UNITED STATES PATENT AND TRADEMARK OFFICE

APPLICATION NO.	FILING DATE	FIRST NAMED INVENTOR	ATTORNEY DOCKET NO.	CONFIRMATION NO.
09/176,580	10/21/1998	RAMESH SUNDARAM	S01.12-0460	2038

Office Action Summary

DETAILED ACTION

attachment #1

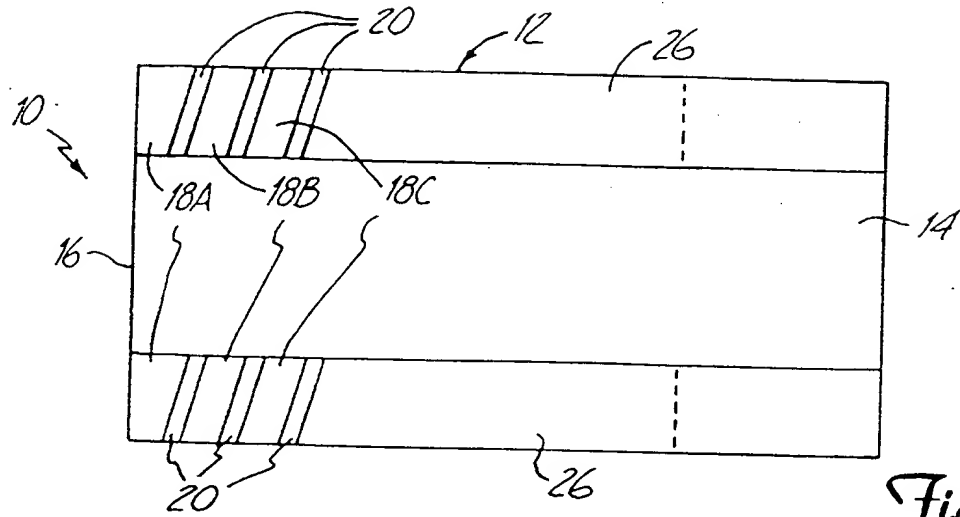
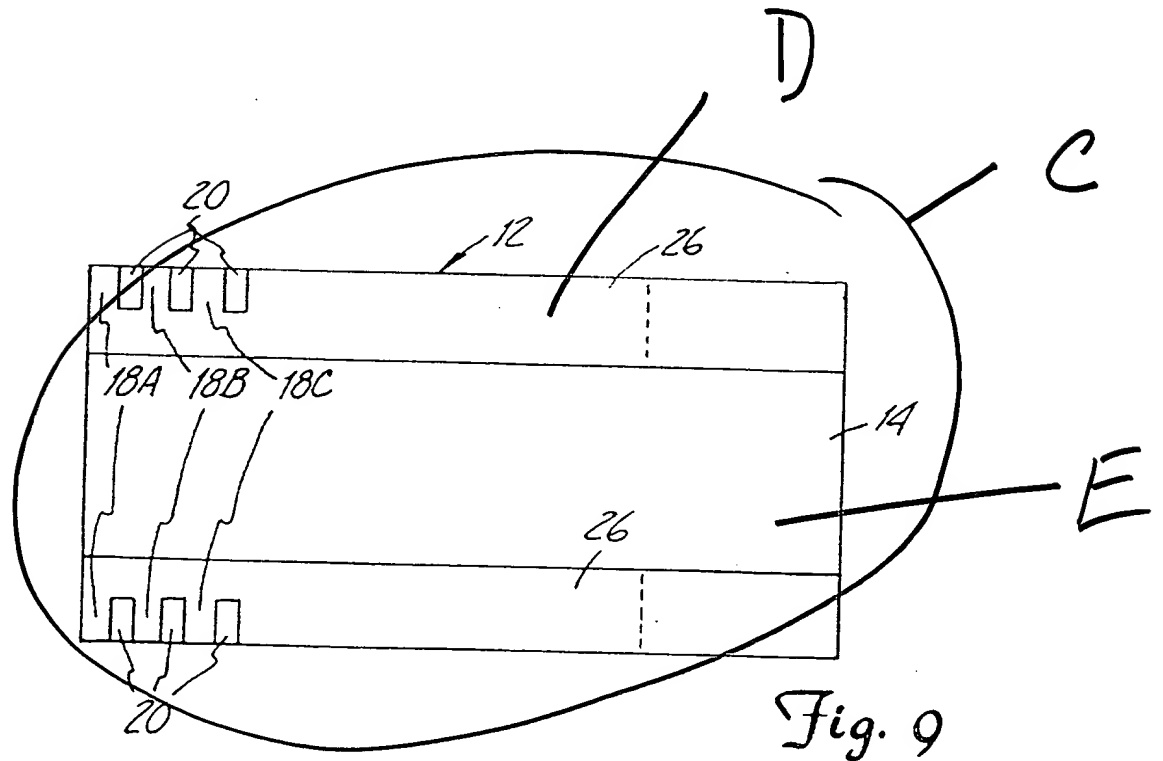
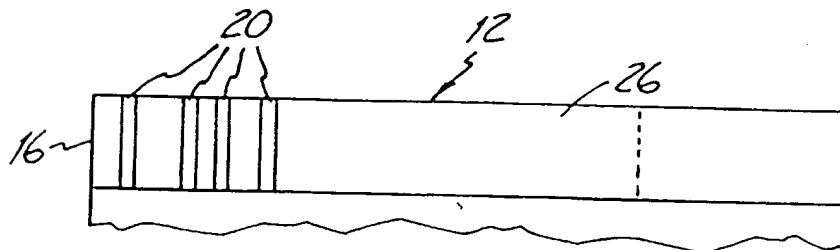
Boutaghou discloses in Figs. 1-4 and 13 a device/ glide test system having a thermal asperity sensor comprising a slider body 12 having a leading edge A, trailing edge, a contoured (having rails) disc facing surface C. The surface C has a raised bearing surface D (26) elevated from a recessed bearing surface E. The device also has transducers (plurality of magnetoresistive sensors/ MR) 18 spaced apart along the length of rails (elevated/ raised bearing surface) 26 of an air bearing surface 14 ABS (col. 6, lines 6-7 and Fig. 1). Each transducer has layers, thus, constituting a thin (having thickness/ height) flat (col. 7, line 20) asperity contacting surface (length) oriented along the ABS. As shown in Fig. 1, the transducers are oriented along (portion extending) the ABS. Inherently, the thickness of the transducer is forming a contour profile of the contoured disc facing surface and is intersecting (contacting) with its portion extending along the ABS.

For claim 29: It is inherent that the ABS must be fabricated prior to depositing the thermal transducers onto it and thus, onto the raised bearing surface of the ABS. (The numerals A- F have been added by the Examiner, see attachment to the Office Action).
